Access Compliance Report

Public Rights-of-Way

(Curb Ramps)

Intersection ID: 46759	Main Street: PONTCHATRAIN_AV	Cross Street: CUMBERLAND_COVE_DR	Location: SE
ADA ID: 30AD71178DF9	Ramp Type: BlendTrans1	Initial Pass/Fail: Fail	Overall Compliance: No
Severity Score: 33.75			
Codes/Mitigation Info/Possible Solution		Field Measurements/Component Compliance

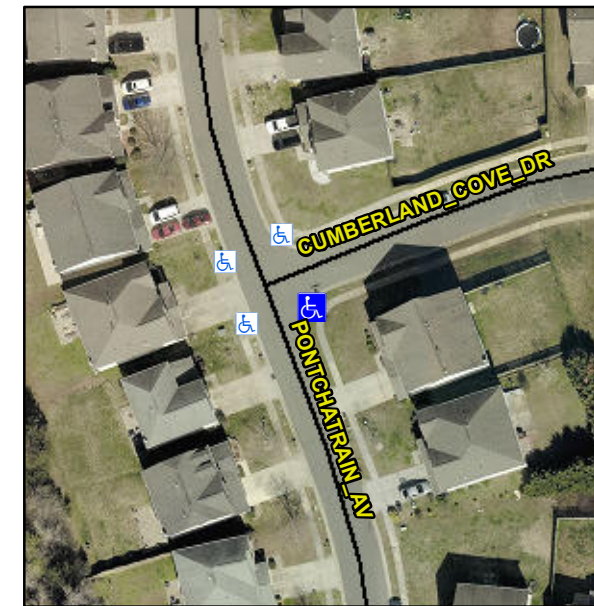
Compliance	Description	Data	Compliance	Description	Data
N/A	Ramp Length (in)	48.0	Yes	BlendTrans Slope (%)	4.6
No	Ramp Width (in)	40.0	No	BlendTrans XSlope (%)	10.1
N/A	Flare Type LT	N/A	N/A	Flare Type RT	N/A
N/A	Flare Slope LT (%)	N/A	N/A	Flare Slope RT (%)	N/A
N/A	Flare Traversable LT?	N/A	N/A	Flare Traversable RT?	N/A
N/A	Landing Length (in)	N/A	N/A	DWS Provided?	N/A
N/A	Landing Width (in)	N/A	N/A	DWS Contrast?	N/A
N/A	Landing Slope (%)	N/A	N/A	DWS Length (in)	N/A
N/A	Landing X Slope (%)	N/A	N/A	DWS Full Width?	N/A
N/A	Landing Curb? (Y/N)	N/A	N/A	DWS Offset (in)	N/A
N/A	Shared Landing?	N/A			
N/A	Gutter Ponding?	N/A	N/A	Gutter Slope (%)	N/A
N/A	Gutter Lip Ht (in)	N/A	N/A	Gutter X Slope (%)	N/A
N/A	Painted X Walk1?	No	N/A	Painted X Walk2?	No
	X Walk 1 Direction	To NW		X Walk 2 Direction	To SW
	X Walk 1 Width (in)	N/A		X Walk 2 Width (in)	N/A
	X Walk 1 Slope (%)	10.1		X Walk 2 Slope (%)	8.7
	X Walk 1 X Slope (%)	4.5		X Walk 2 X Slope (%)	4.3

N/A	Ramp inside XWalk1?	N/A	N/A	Ramp inside XWalk2?	N/A
	Road Slope (%)	8.5		Clear Space?	N/A
	Road X Slope (%)	3.1	N/A	Clear Space to XWalk (in)	N/A
N/A	Any Obstructions?	N/A	N/A	Storm Grate/Utility Hazard?	N/A
	Obstruction Type			Storm Grate/Utility Type	
		N/A			N/A
			Yes	Surface Condition? (G/P)	Good
			N/A	Curb Slope (%)	2.8

Remove & Replace Curb Ramp With Two New Directional Ramps or Equivalent.
